NWBPCR Community Meeting #4 Report Out December 7, 2022

Manhattan Community Board 1 Battery Park City Committee

Provide responses to Community Board 1 to inform their resolution related to the Draft Scope of Work before the comment period for the Scoping Document ends on December 31. We will:

REACH 1
BMCC / HRPK

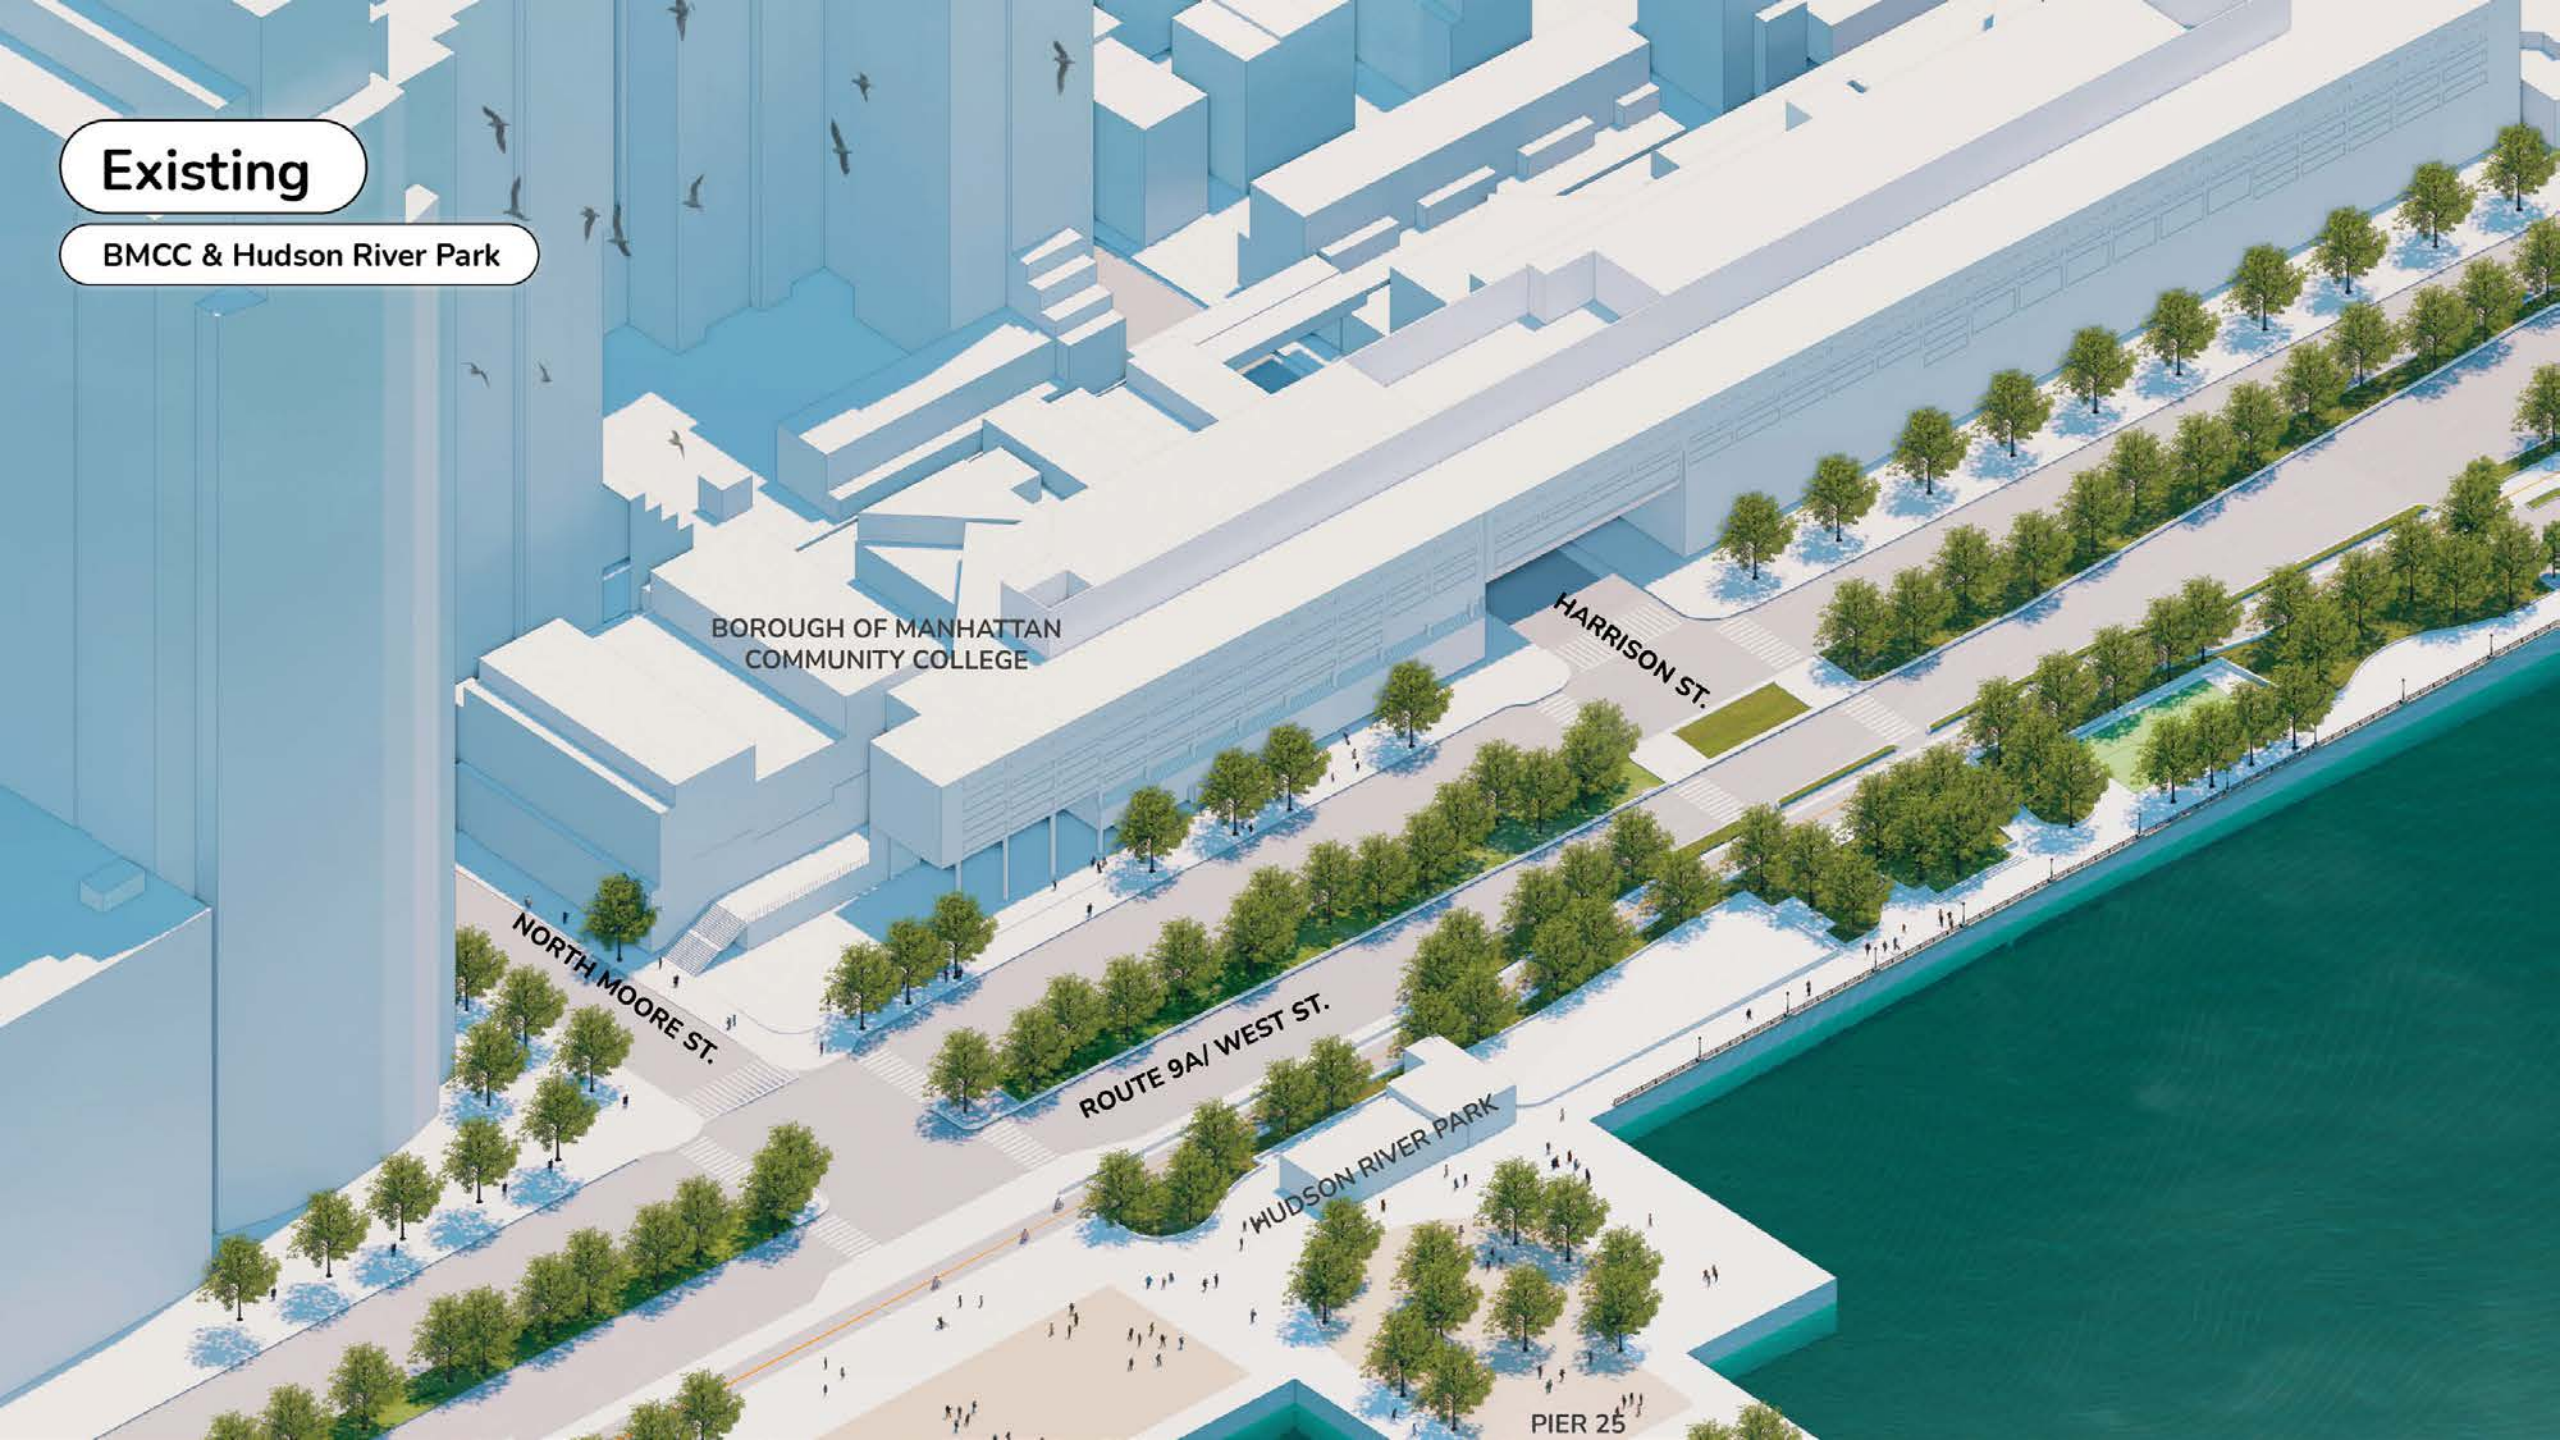
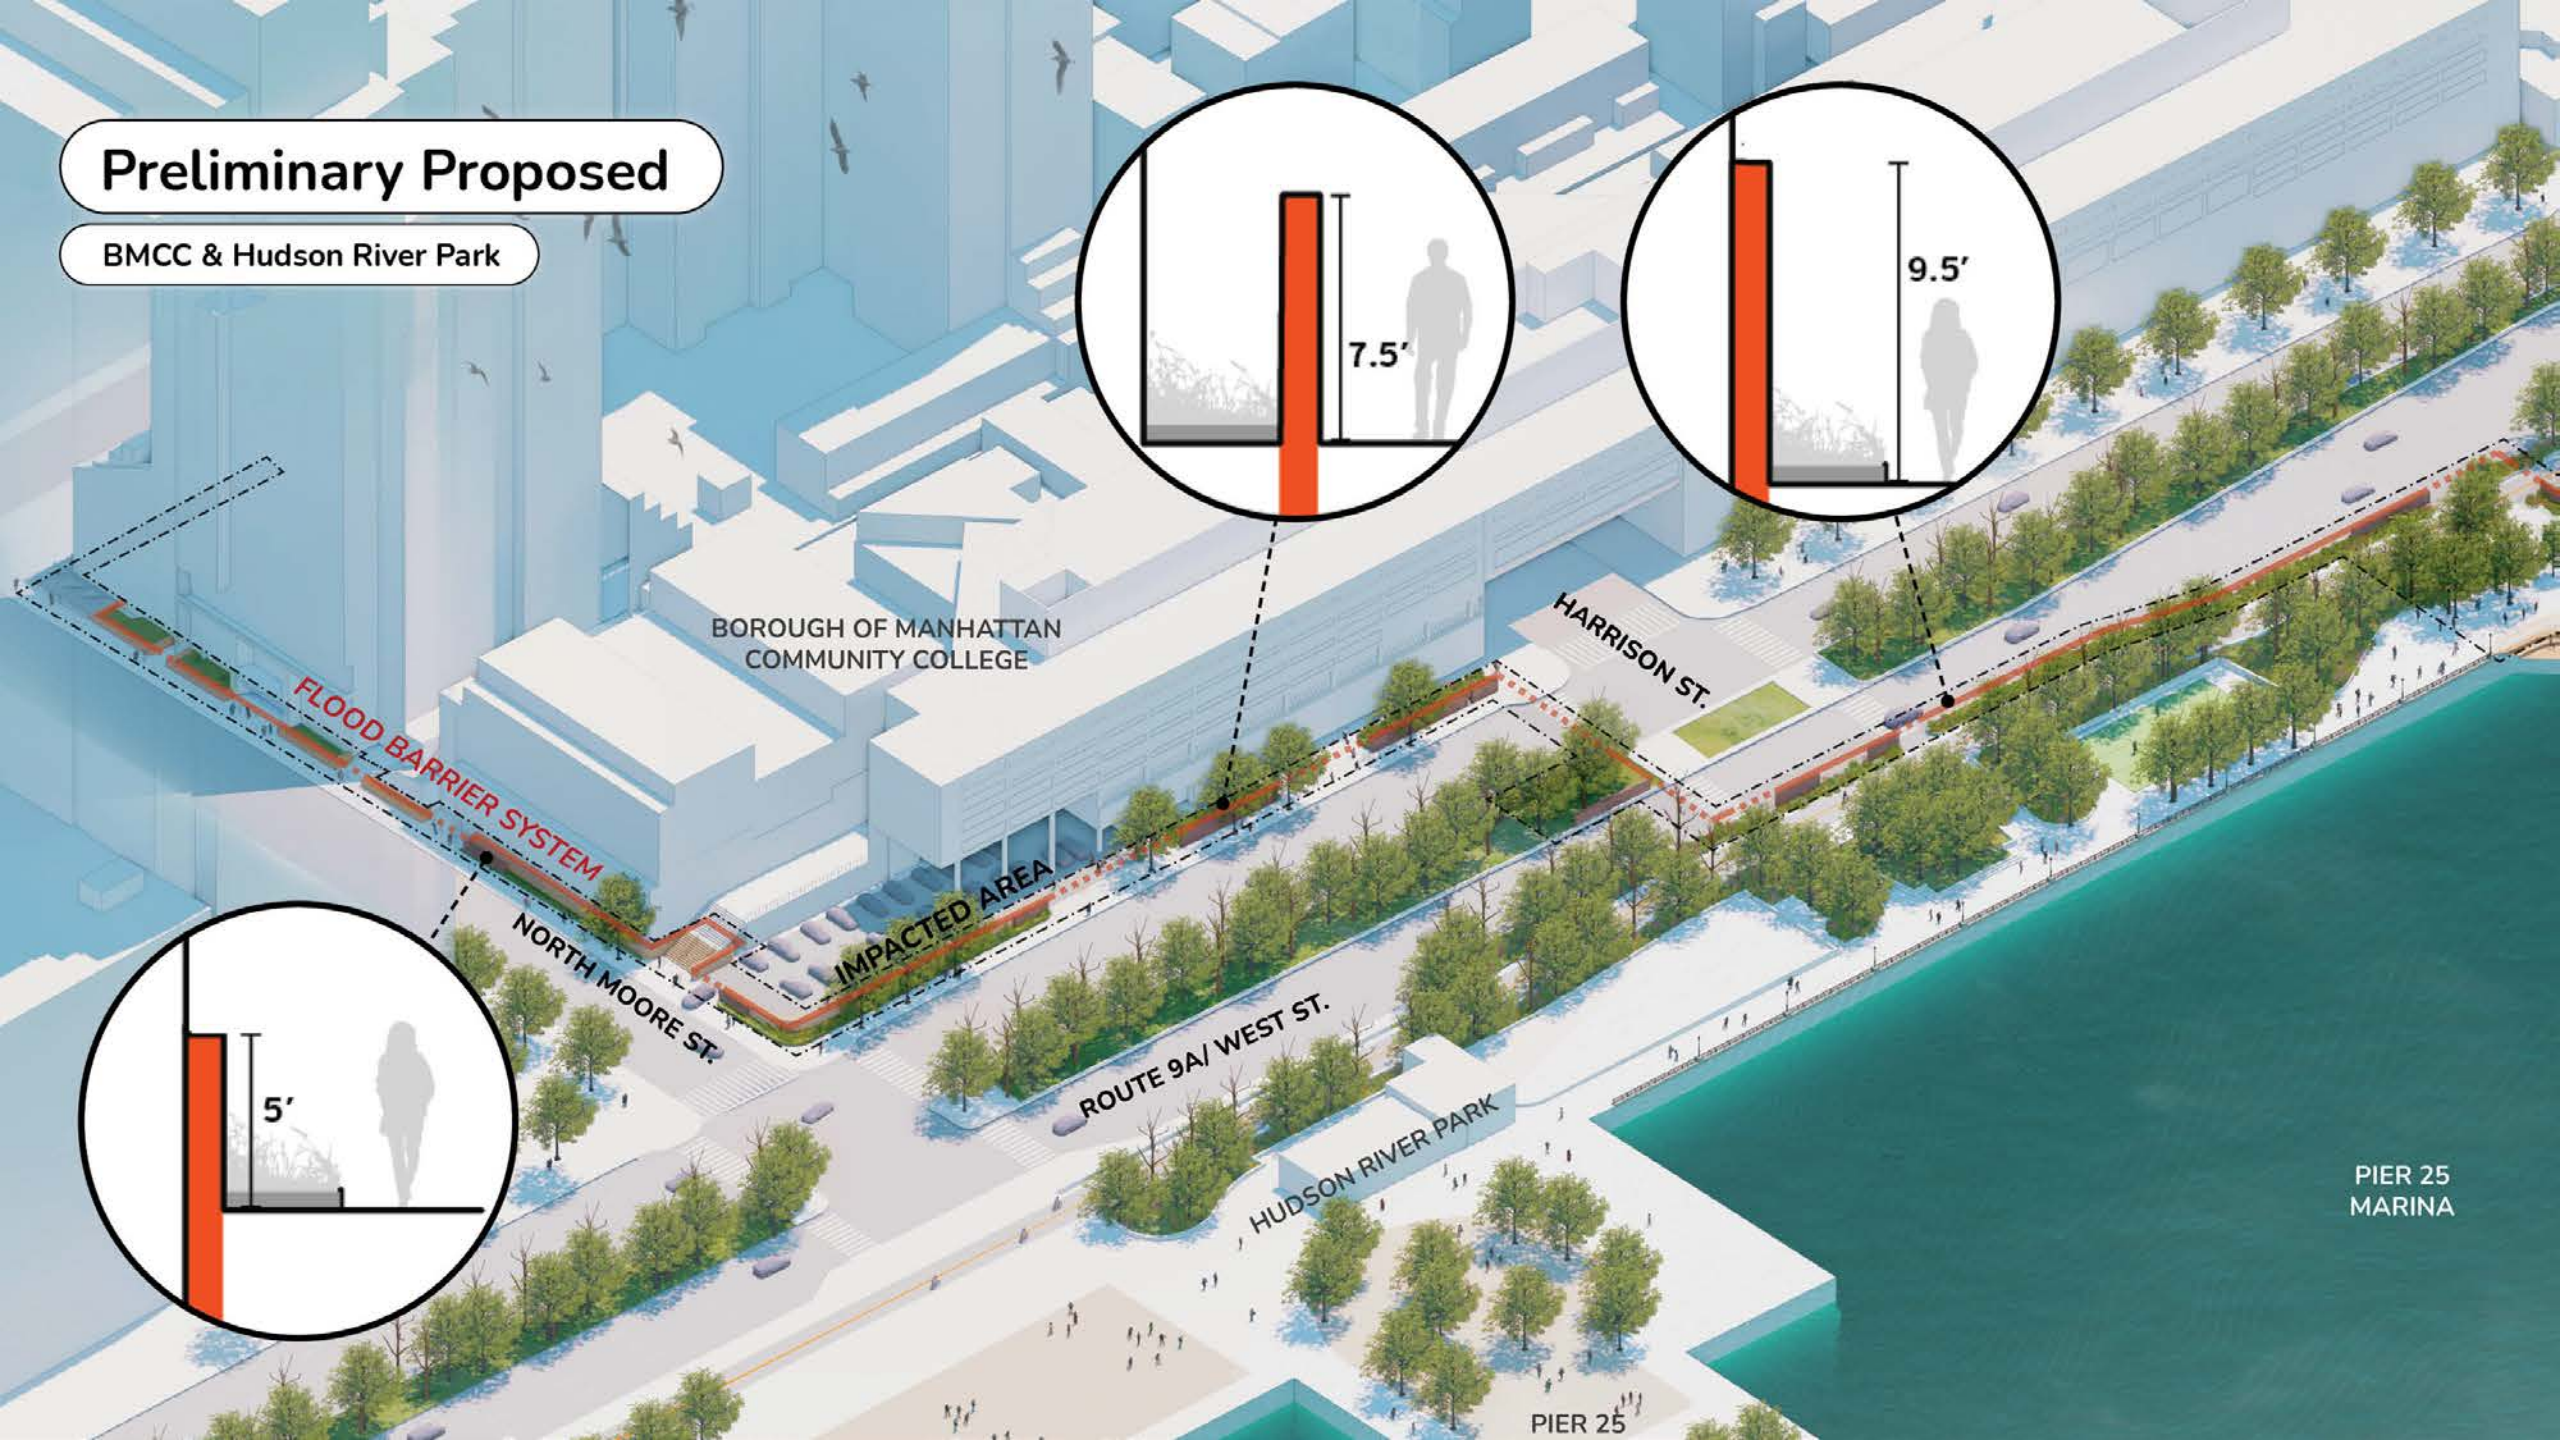
1. How would this impact pedestrian use on N Moore St.?
2. If the modeling will not allow for Reach 1B, could this be improved by putting the barrier between the bike path and the west side highway, rather than between the pedestrian and bike paths? That would provide an additional sound/pollution barrier for bikers and pedestrians, which would be an added benefit.
3. Can you describe more how this would impact Washington Market, especially considering construction closure of green space along Battery Park? Where are parents and little kids supposed to go during construction?

- I do not understand Reach 1 and need better visuals on this one and more to opine on it. I hear this from many in the community.
- The images are too low resolution to be legible. Please post hi res pdf. Thank you.
